ALERT SERVICE BULLETIN

TITLE: EMERGENCY FLOATATION SYSTEM - CHECK OF FLOAT HOSES RETAINING RING

Model:	EC120
Version:	B

SERVICE BULLETIN
**TITLE: EQUIPMENT/FURNISHINGS (ATA 25)
EMERGENCY FLOTATION SYSTEMS (EFS)
INSPECTION OF FLOAT HOSES RETAINING RING**
1. [PLANNING INFORMATION](#)
A. Effectivity
(1) Equipment involved

Figure 1 – Remove the adhesive tape

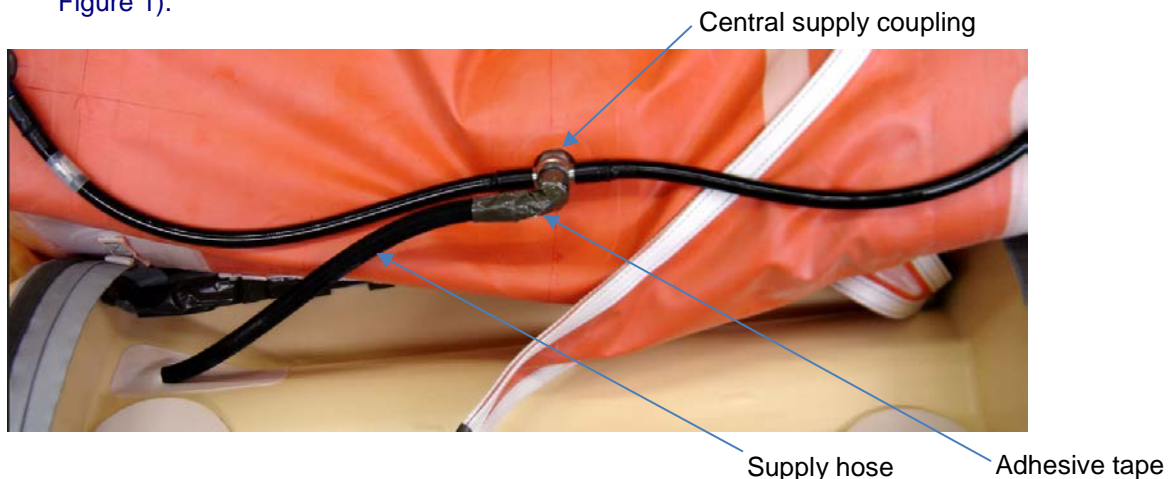
- (1) Locate the position of the central supply coupling on the float bag.
- (2) Remove and discard the adhesive tape that surrounds the supply hose connection (refer to Figure 1).

Figure 2 – Retaining ring location

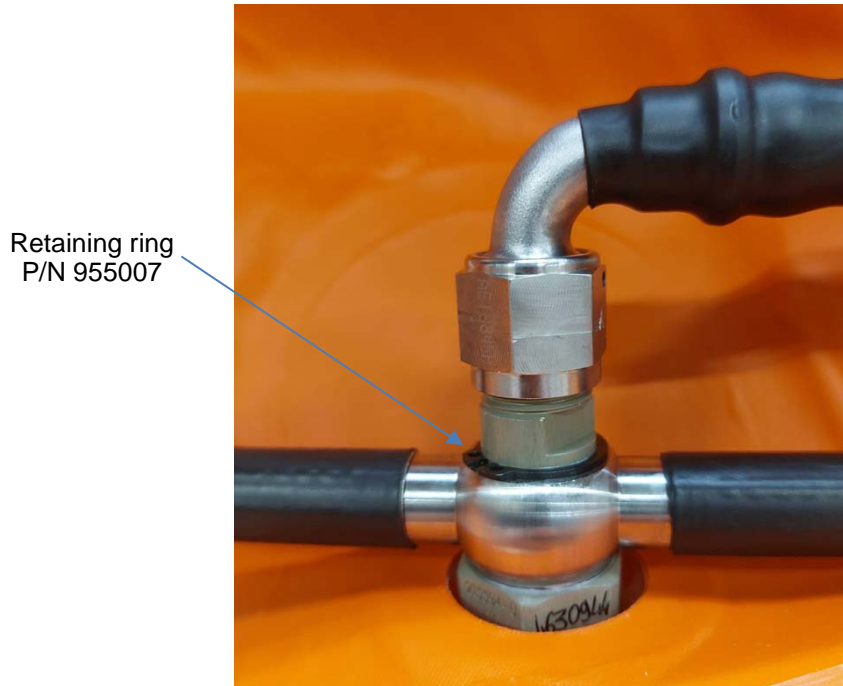
- (3) Do the inspection of the supply hose / central supply coupling connection for presence of the retaining ring (refer to Figure 2):

- (a) If the retaining ring is present:
- 1 Wrap again the supply hose connection with new adhesive tape (refer to section 2.C.(2).).
- (b) If the retaining ring is missing:
- 1 Remove the supply hose from the central supply coupling.
NOTE: Refer to the related CMM for disassembly instructions (refer to section 1.K.).
 - 2 Install the retaining ring (P/N 955007) (refer to section 2.1.A.) on the central supply coupling.
 - 3 Re-install the supply hose on the central supply coupling (refer to section 2.C.(2).).
NOTE: Refer to the related CMM for assembly instructions (refer to section 1.K.).
 - 4 Wrap again the supply hose connection with new adhesive tape (refer to section 2.C.(2).).
